Product hierarchy no. *	Part no.	SBU	Type / Description	Customer part no.			
SBU PG PUG Type							
02 007 013 0000002297	See list below	Connectors	4797 Appliance Outlet 16A 70°				
*SBU (2-digit) / PG (3-digit) / PUG (3-digit) / Type (10-digit)

Product Change Notification			PCN - 4797 Cord Retention Notches Added				
owner	creation date	release date	released by	change order no	rev	page	D10 024 720
vettersa	08.07.2019	14.08.2019	limachcl	2017298	В	1 of 2	D10-034-720

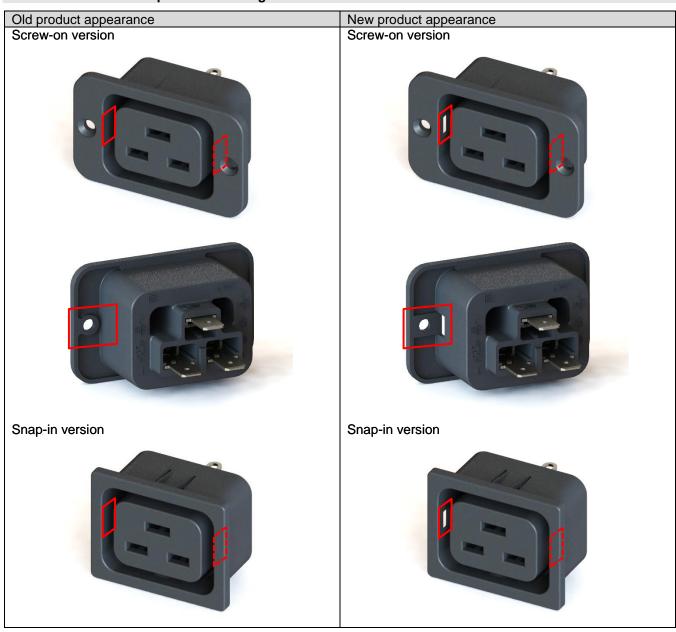
Two laterally positioned notches added to the molding body.

The notches are implemented as a standard feature to be compatible with side latching cord retention systems such as P-Lock, SecureLock or TwyLock.

Form Yes Laterally positioned notches. Fully backwards compatible

Function Yes Compatibility with side latching cord retention systems
